Technical Bulletin 188

03.2018

Contents

Circuit Diagram

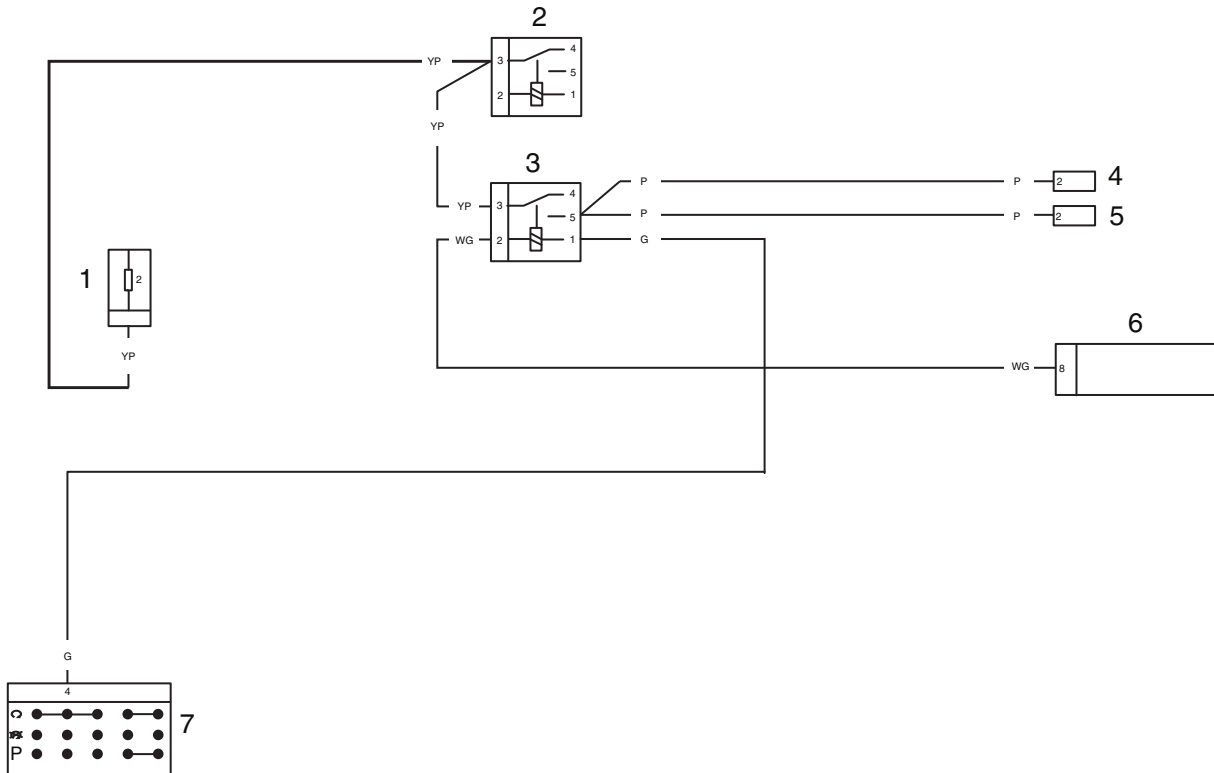
3. If fog lights are fitted but the relay is not fitted, fit the relay. Refer to EPC for part number.
4. If the FOG LIGHTS FAULT warning is still illuminated, check the harness for open circuit between the instruments and the fog light relay connector (see Fog Light Fault - Pinpoint Test below).

Test	Result	Action
1 Check cable and terminal integrity: - Instrument connector pin 8 and fog light relay pin 2 Ignition switch pin 4 and fog light relay pin 1	OK	Proceed to test 2
	Faulty	Rectify fault, proceed to test 4
2 Check cable continuity: - Instrument connector pin 8 and fog light relay pin 2	OK	Proceed to test 3
	Faulty	Locate and rectify fault, proceed to test 4

3	Check cable continuity: -Ignition switch pin 4 and fog light relay pin 1	OK	Proceed to test 4
		Faulty	Locate and rectify fault, proceed to test 4
4	Test the fog lights	OK	Action complete - quit test
		Faulty	Contact Triumph service

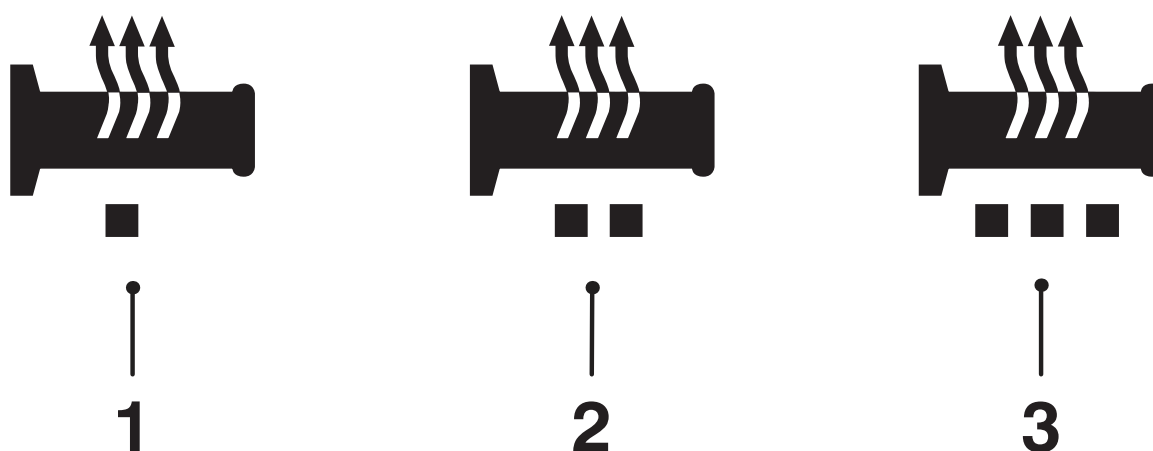
New TFT instrument calibrations have been released for the above models. The new calibrations improve heated grip functionality (if fitted) to allow three levels of heat to be selected.

There are three levels of heat: low, medium and high. This is indicated by the different colours of the symbols shown in the display.

1. Low heat symbol (yellow)
2. Medium heat symbol (orange)
3. High heat symbol (red)

Stage 1:

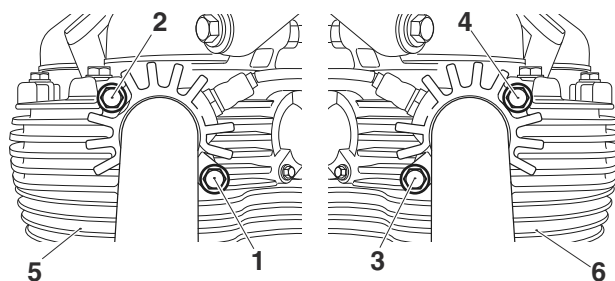
The exhaust header tightening sequence and torque figures have been updated for the above models. When refitting an exhaust header pipe to the above models, follow the new exhaust header tightening sequence as described in the procedure below:

- Tighten the exhaust header pipe lower nut (1) to **10 Nm**
- Tighten the exhaust header pipe upper nut (2) to **10 Nm**
- Re-tighten the exhaust header pipe lower nut (1) to **10 Nm**

- Tighten the exhaust header pipe lower nut (3) to **10 Nm**
- Tighten the exhaust header pipe upper nut (4) to **10 Nm**
- Re-tighten the exhaust header pipe lower nut (3) to **10 Nm**.

Item: 188.5
Description: Hugger Fixing
Model Affected: Tiger Sport

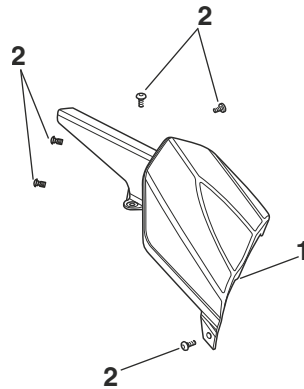
A M5 x 10 mm encapsulated fixing has replaced the original M5 x 14 mm fixing, therefore if loosened or removed for any reason the original fixing must be replaced and torqued to **4 Nm**.

Circuit Diagram

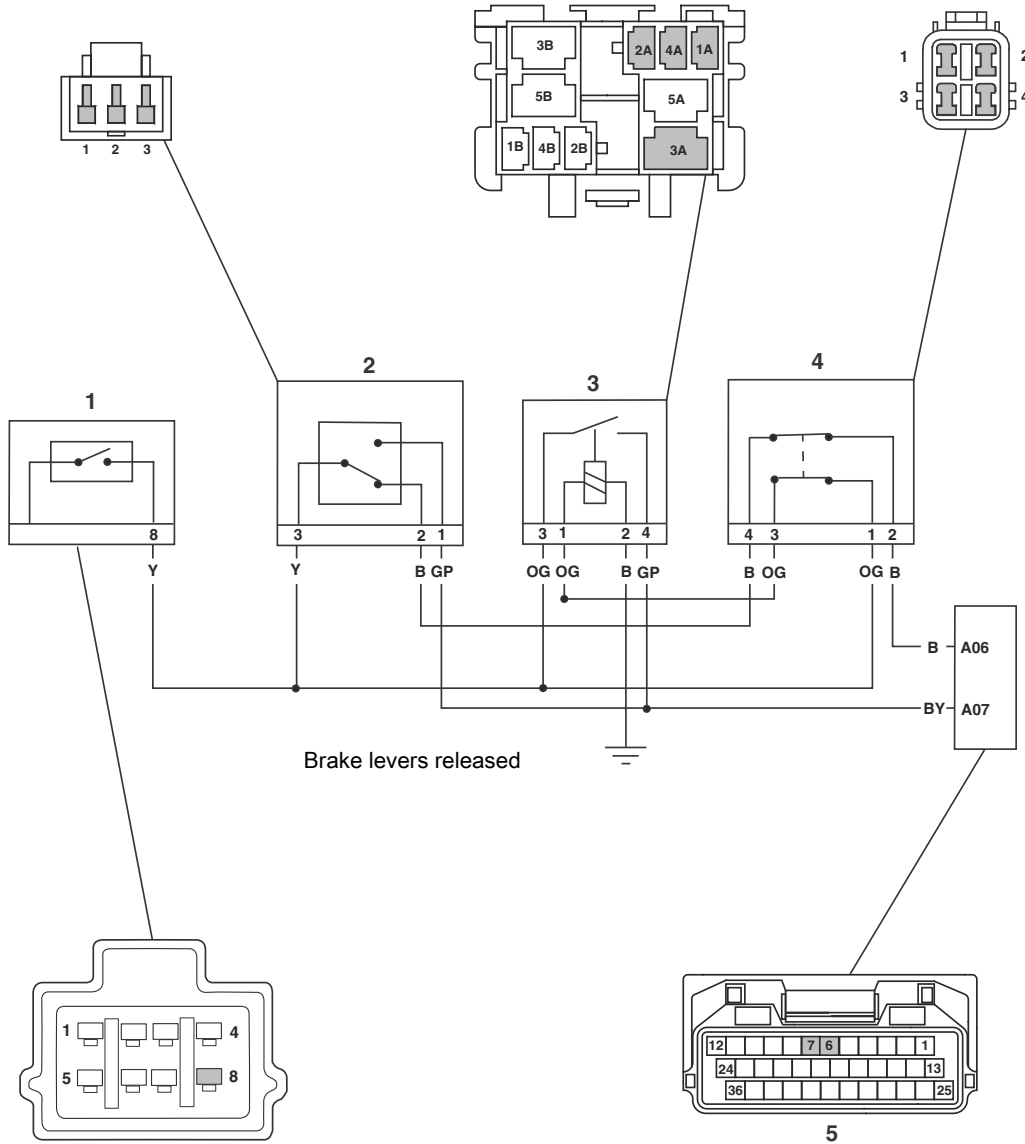
The pinpoint test for Brake Switches (P1567) has changed for the above models Service Manuals. The changes are in the Pinpoint Test - Fuel section within the Fuel System and Engine Management chapter. The revised pinpoint test is as described below.

Test	Result	Action
1	Turn ignition on, operate rear brake switch and check brake light operation.	OK	Proceed to test 2
		Faulty	Rectify fault, proceed to test 6
2	Check cable and terminal integrity: - ECM pin A06 - ECM pin A07 - Ignition switch pin 8	OK	Disconnect front and rear brake switch connectors, proceed to test 3
		Faulty	Rectify fault, proceed to test 6
3	With brakes released, check front and rear brake switch operation: The following should be short circuit: - Front brake switch pin 2 to pin 3 - Rear brake light switch pin 2 to pin 4 - Rear brake light switch pin 1 to pin 3 The following should be open circuit: - Front brake switch pin 1 to pin 3 With the front brake switch pressed the following should be short circuit: - Front brake switch pin 1 to pin 3 The following should be open circuit: - Front brake switch pin 2 to pin 3 With the rear brake switch pressed the following should be open circuit: - Rear brake light switch pin 2 to pin 4 - Rear brake light switch pin 1 to pin 3	OK	Proceed to test 4

Test	Result	Action
4	Re-Connect the brake switch connectors. Check cable continuity: - Engine ECM pin A07 to front brake switch pin 1 - Engine ECM pin A06 to rear brake switch pin 2 - Engine ECM pin A07 to brake switch relay pin 4 - Brake switch relay pin 2 to ground - Engine ECM pin A06 to front brake switch pin 2 - Engine ECM pin A06 to ignition switch pin 8	OK	Proceed to test 5
		Open Circuit	Locate and rectify wiring fault, proceed to test 6
5	Re-Connect the brake switch connectors. With the ignition switch on, measure the following Voltages: - Engine ECM pin A06 to ground - Rear brake switch pin 1 to ground - Rear brake switch pin 2 to ground - Rear brake switch pin 3 to ground - Rear brake switch pin 4 to ground - Brake switch relay pin 3 to ground - Brake switch relay pin 1 to ground - Front brake switch pin 3 to ground - Front brake switch pin 2 to ground	greater than 10V	Proceed to test 6

Less than 10V	Locate and rectify wiring fault, proceed to test 6
6	Reconnect harness, clear fault code and run engine.	OK	Action complete - quit test
		Fault still present	Contact Triumph service

Circuit Diagram

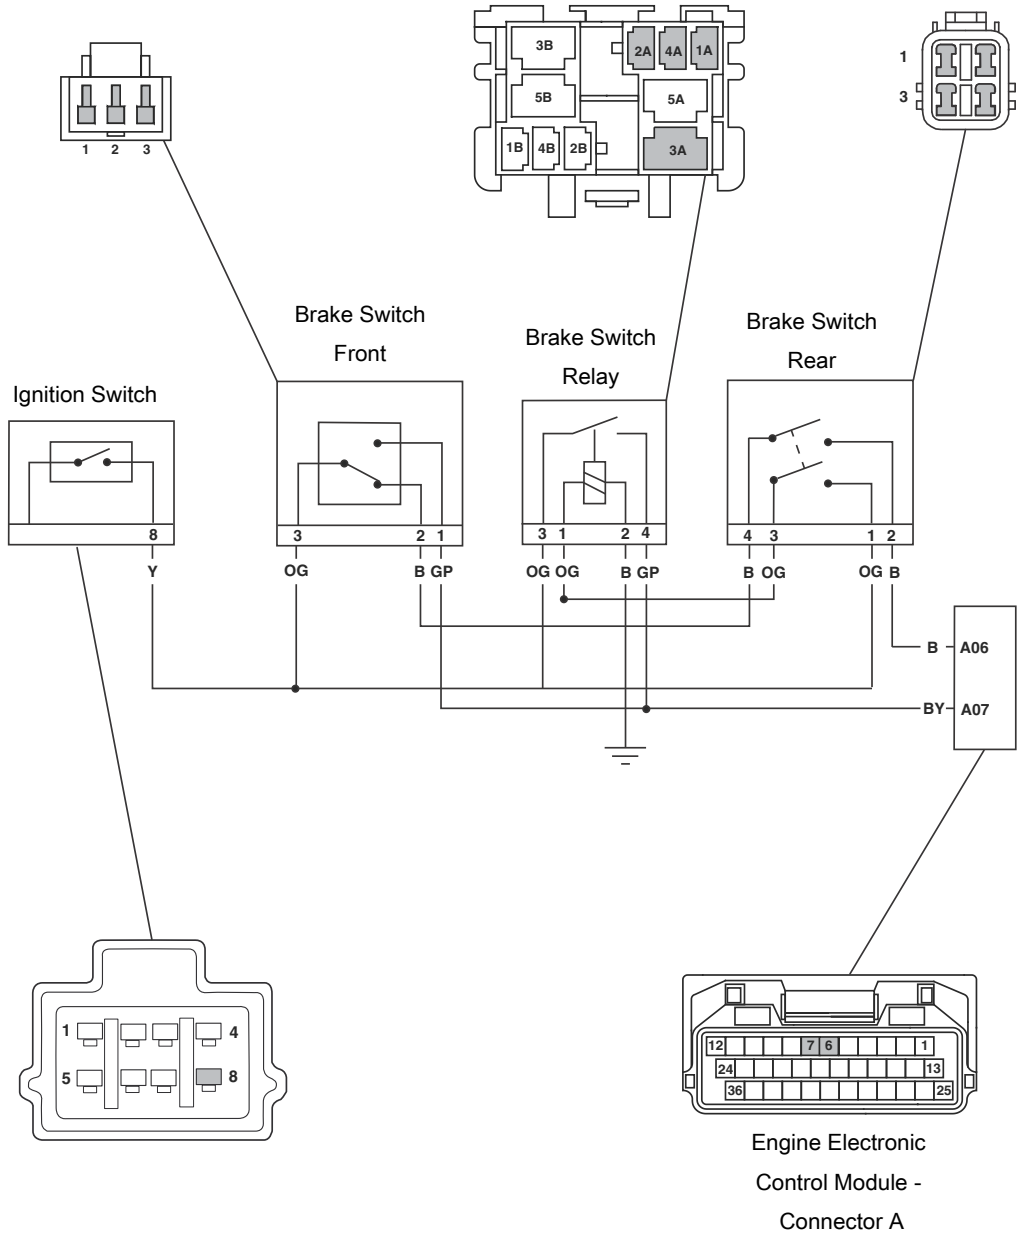
The pinpoint test for Brake Switches (P1567) has changed for the above models Service Manuals. The changes are in the Pinpoint Test - Fuel section within the Fuel System and Engine Management chapter. The revised pinpoint test is as described below.

Test	Result	Action
1	Turn ignition on, operate rear brake switch and check brake light operation.	OK	Proceed to test 2
		Faulty	Rectify fault, proceed to test 6
2	Check cable and terminal integrity: - ECM pin A06 - ECM pin A07 - Ignition switch pin 8	OK	Disconnect front and rear brake switch connectors, proceed to test 3
		Faulty	Rectify fault, proceed to test 6
3	With brakes released, check front and rear brake switch operation: The following should be short circuit: - Front brake switch pin 2 to pin 3 - Rear brake light switch pin 2 to pin 4 - Rear brake light switch pin 1 to pin 3 The following should be open circuit: - Front brake switch pin 1 to pin 3 With the front brake switch pressed the following should be short circuit: - Front brake switch pin 1 to pin 3 The following should be open circuit: - Front brake switch pin 2 to pin 3 With the rear brake switch pressed the following should be open circuit: - Rear brake light switch pin 2 to pin 4 - Rear brake light switch pin 1 to pin 3	OK	Proceed to test 4

Test	Result	Action
4	Re-Connect the brake switch connectors. Check cable continuity: - Engine ECM pin A07 to front brake switch pin 1 - Engine ECM pin A06 to rear brake switch pin 2 - Engine ECM pin A07 to brake switch relay pin 4 - Brake switch relay pin 2 to ground - Engine ECM pin A06 to front brake switch pin 2 - Engine ECM pin A06 to ignition switch pin 8	OK	Proceed to test 5
		Open Circuit	Locate and rectify wiring fault, proceed to test 6
5	Re-Connect the brake switch connectors. With the ignition switch on, measure the following Voltages: - Engine ECM pin A06 to ground - Rear brake switch pin 1 to ground - Rear brake switch pin 2 to ground - Rear brake switch pin 3 to ground - Rear brake switch pin 4 to ground - Brake switch relay pin 3 to ground - Brake switch relay pin 1 to ground - Front brake switch pin 3 to ground - Front brake switch pin 2 to ground	greater than 10V	Proceed to test 6

Less than 10V	Locate and rectify wiring fault, proceed to test 6
6	Reconnect harness, clear fault code and run engine.	OK	Action complete - quit test
		Fault still present	Contact Triumph service
